gDC Consensus Discussion

Recap of last time... (draft 1.1)

Table 120G–9—Eye opening reference receiver parameter values

TP1a Values

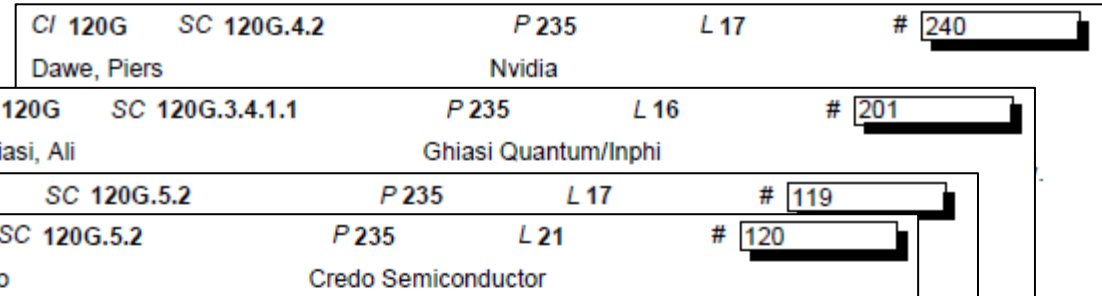
gDC					Regardless of frequency
gDC2	D1.2	Dudek (#225) & Hidaka (#117)	Hidaka (#118)	D1.1	
0	-2 to -9	-3 to -9 <small>Comment #117</small>	-3 to -13	-3 to -14	
-1, [-0.5]	-2 to -12	-3 to -12			
-2, [-1.5]	-4 to -12	-4 to -12			
-3, [-2.5]	-8 to -13	-6 to -13 <small>Comment #225</small>			
gDC2 count	7	7	7	4	
	8+22+18+16= 64	8+22+18+12= 60	11*7 = 77	12*4 = 48

7/28 discussion showed no consensus to make a change. And pointed out error in slide gDC(gDC2=-3) in D1.2 and #225, corrected above. It is unclear if comment #225 needs to be re-addressed

Proposed accept the values modifications on previous slide, leave dependence of gDC and gDC2.
